# AGENDA

## **DEVELOPMENT DETERMINATION PANEL MEETING**

**WEDNESDAY 22 MAY 2024**

**ITEM 3.1      DA2024/0265 - 29 CAROLYN AVENUE BEACON HILL -  
ALTERATIONS AND ADDITIONS TO A DWELLING HOUSE**

Figure 1. Extraction from master set plans, drawing no. DA.10, Issue E, Section ZZ, dated 11 March 2024 - extent of building height breach indicated in purple.

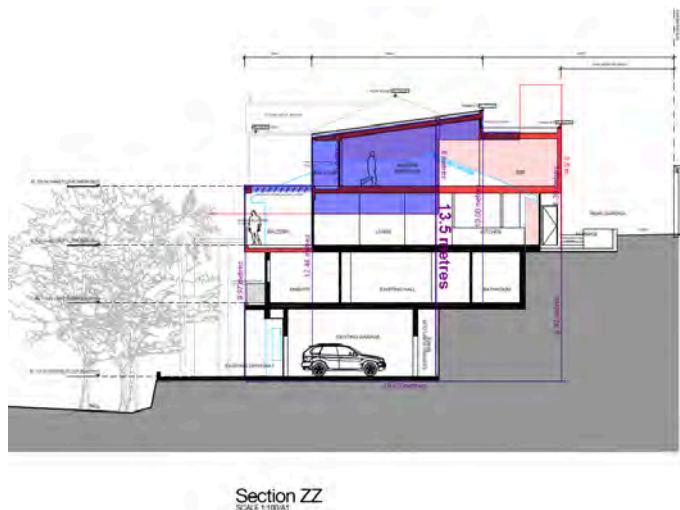
Percentage of variation: 58.8%

With reference to Section 35B of the *Environmental Planning and Assessment Regulation 2021*, the development application is/is not accompanied by a document that sets out the grounds on which the Applicant seeks to demonstrate the matters set out in Clause 4.6(3)(a) and (b) of the WLEP 2011 (the 'Clause 4.6 Request').

Figure 2. Proposed eastern elevation wall height breach. Extent of breach indicated in pink shading (existing approximate breach indicated by purple shading).

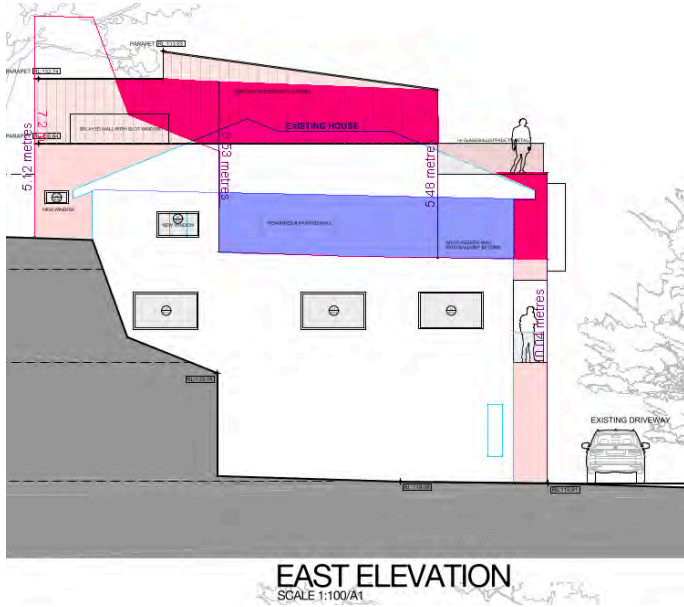
This control requires development to result in wall heights no greater than 7.2 metres. Due to the slope of the land, the proposed development extends beyond the maximum wall height along both the eastern and western elevations, as indicated in the figures below.

Figure 3. Proposed western elevation wall height breach. Extent of breach indicated by pink shading (existing approximate breach indicated by purple shading).

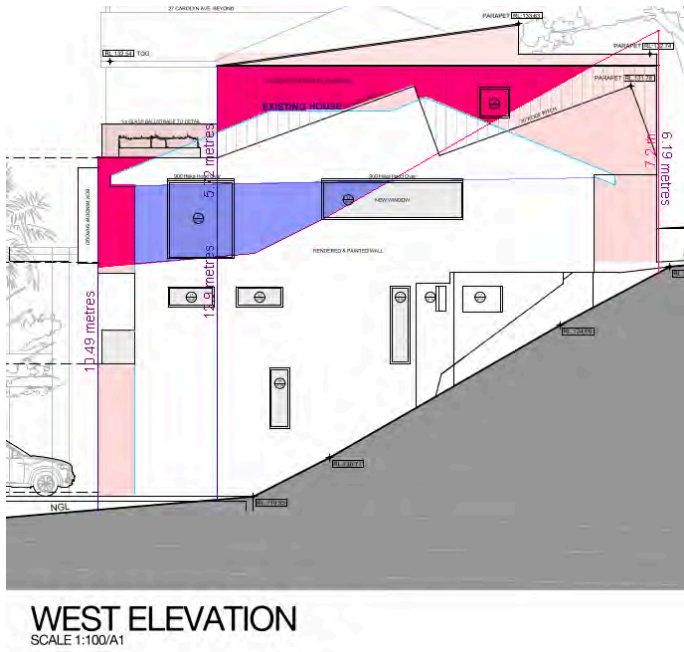
An exception may be permitted which allows the requirements of this control to be varied on sites with slopes greater than 20% below the building footprint, provided that the building does not exceed 8.5 metres, is designed and located to minimise the bulk and scale and has a minimal visual impact when viewed from the downslope sides of the land. As the proposed maximum height exceeds 8.5 metres, the exception cannot be applied, notwithstanding the fact the building footprint is sited on a slope of

**Figure 1: Height blanket diagram showing the proposed building height breaching elements above the 10.0 metre height plane (source: Mathieson)**

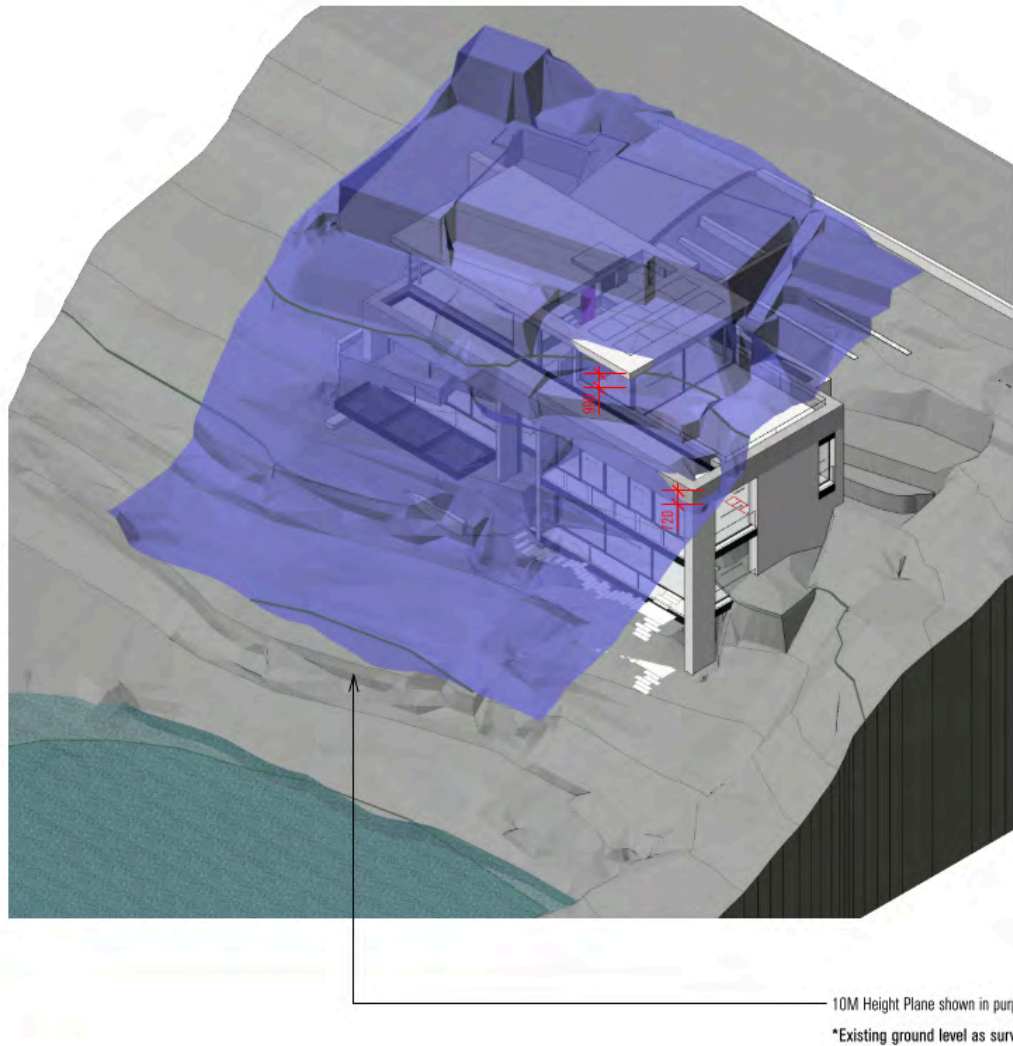
- The proposed modifications will extend the proposed roof to the west (down-slope) by 3.6 metres. This will result in the proposed roof over the level 2 gym having maximum height of 11.0 metres. This is depicted in Figure 1 below.
- Modifications are proposed to the parapeted balcony framing element to increase this by 0.7 metres. This will result in the southwest corner having maximum height of 10.7 metres. This is depicted in Figure 1 below.

**Figure 2: Approved southern building envelope non-compliance (source: Mathieson)**

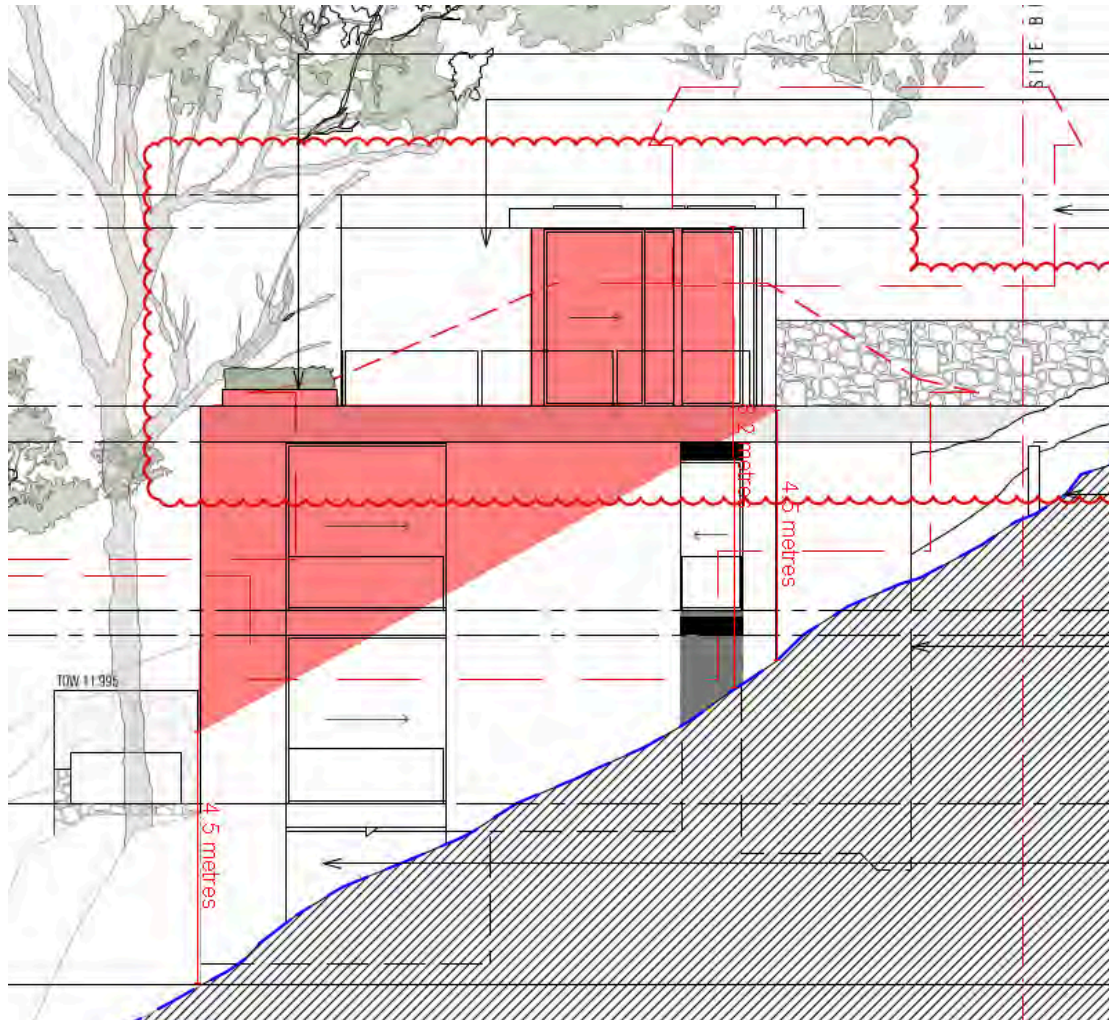
approved Level 1 breach, as the modification proposes to increase the parapeted balcony framing element by 0.7 metres.

**Figure 3: Proposed southern building envelope non-compliance (source: Mathieson)**

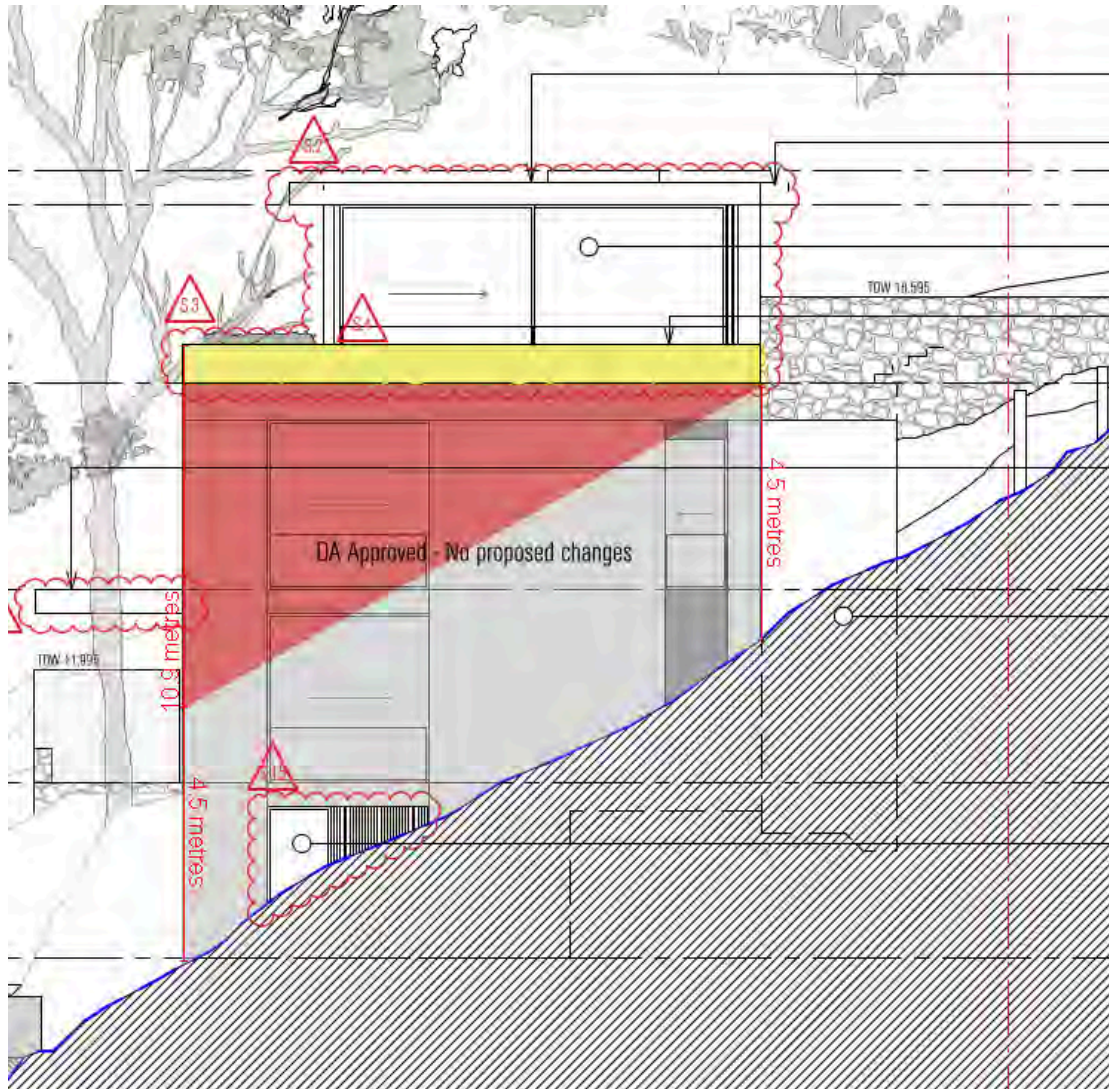
The approved envelope breach on the northern elevation would remain unaltered from the proposed modifications. The proposed envelope non-compliance (subject of this modification) is represented in yellow on the figure below:

Overall, it is considered that the minor additional breach in building envelope is not considered to result in unreasonable impacts to the character of the development as viewed from the street and would not result in unreasonable amenity impacts to the adjoining neighbour. The envelope breach would be a direct result of existing built form and the significant slope of the site. Therefore, a variation to the control can be considered in this circumstance given the minimal impacts the variation presents in terms of amenity and visual impact from the streetscape.

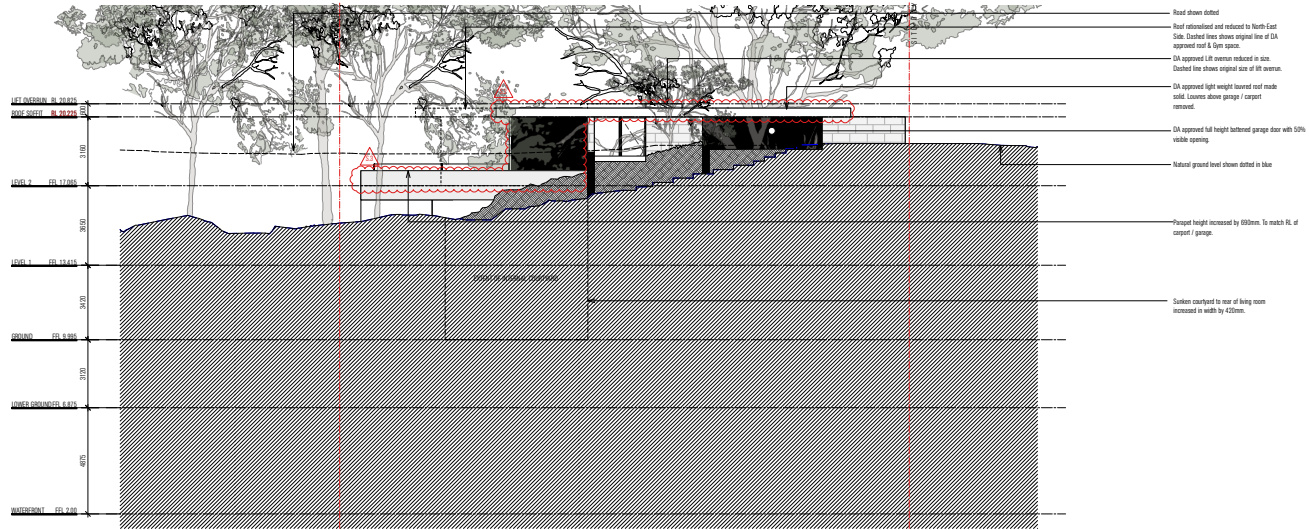
The following amendments are to be made to the approved plans:

- The lower ground level (Identified as Lower Ground on drawing S455.06) is to be reinstated to as approved in DA2021/2447. For the avoidance of doubt no works to the lower ground are approved under Mod2023/0556.

Details demonstrating compliance are to be submitted to the Certifying Authority prior to the issue of the construction certificate.

**Figure 10. Front building line encroachment.**

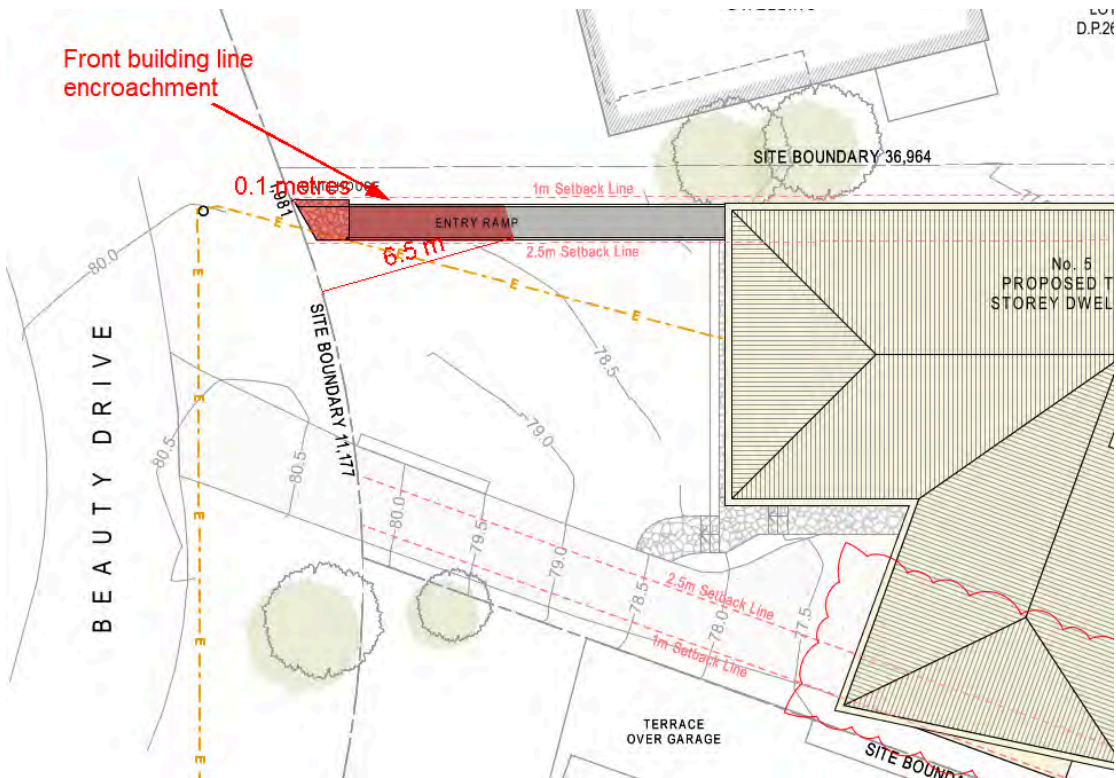
Built structures, other than driveways, fences and retaining walls are not permitted within the front building setback. The minimum front building line is 6.5m for the site. The proposal involves a varied front setback up to 0.1m (gatehouse/entry ramp) given the angled frontage, as displayed within the below diagram.

Figure 11. Side and rear setback non-compliance

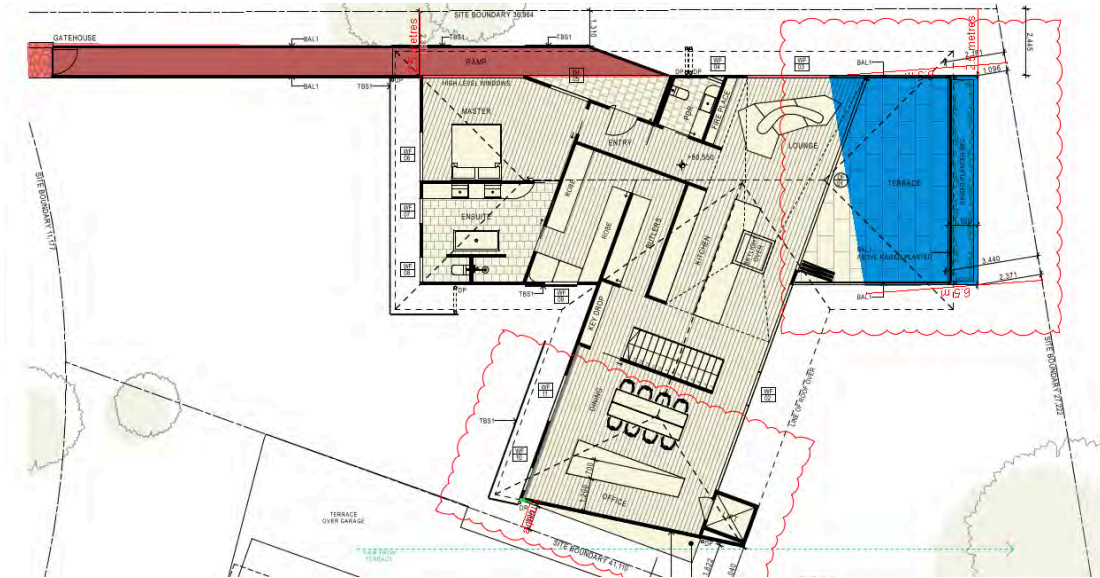
The site is highly irregular in shape and has a number of site constraints to design around including the position of the existing dwelling. The variation to the setbacks are diagrammatically displayed below.

**Figure 12.** North-east side boundary envelope encroachments as indicated in red and yellow

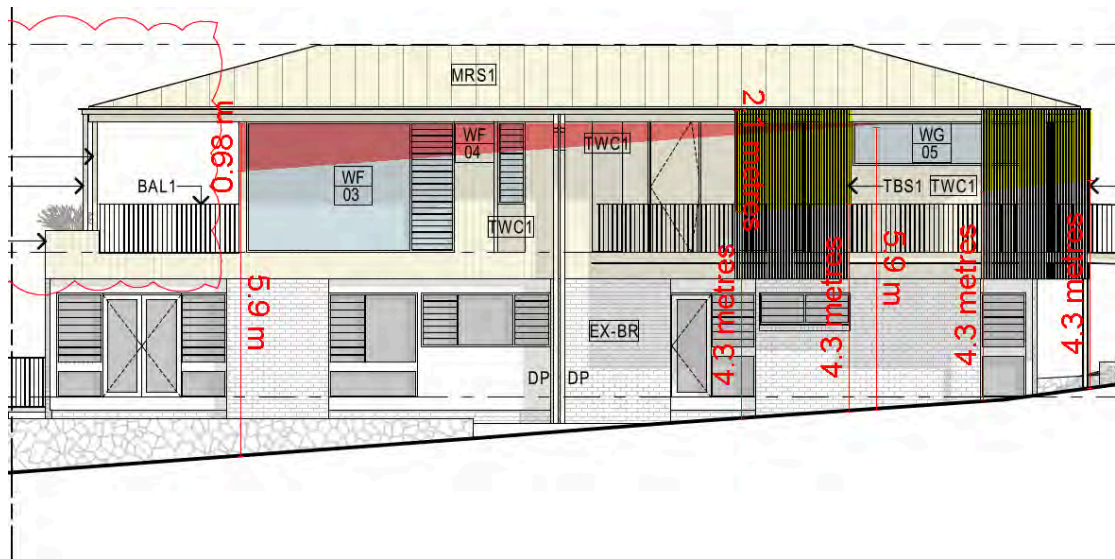
The proposal encroaches the building envelope on both side boundaries. The extent of the building envelope non-compliance is shown in the figures below:
